SERVICE BULLETIN	
	Flight Design GmbH Sielminger Str. 51 D-70771 L.-Echterdingen Tel +49 (0)711 90287-0 Fax +49 (0)711 90287-99 E-Mail: airworthiness@flightdesign.com	SB-ASTM-CTSW-07 Revision 00
	Date of Initial Publication: 30-Nov-2009 Publication Date of this Revision: 30-Nov-2009

Stabilizer Rear Wall Stiffening SB-ASTM-CTSW-07

4.2 Pictures

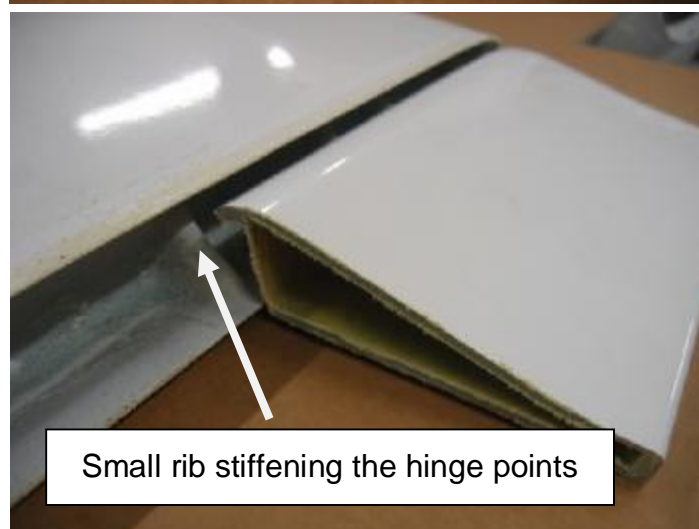
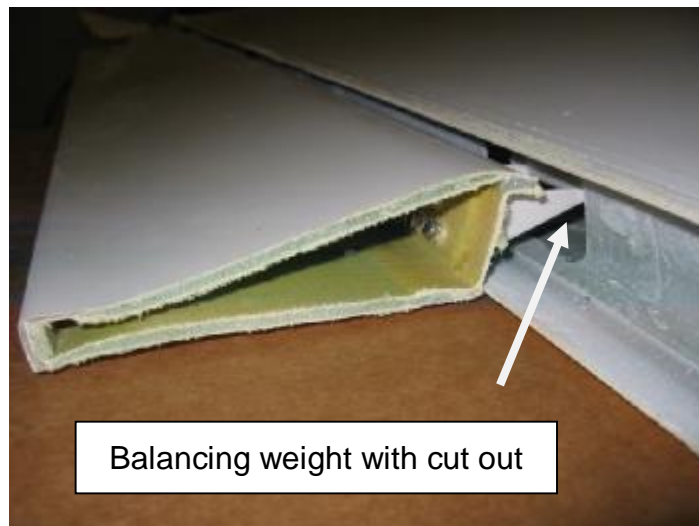
Stiffening of the rear wall of the stabilizer by installation of ribs in the cut-outs for the balancing weights, and direct support of the individual hinge points with small ribs.

Pictures in the Appendix of this SB illustrate balancing weights with cut outs and the small ribs, which supports each hinge point.
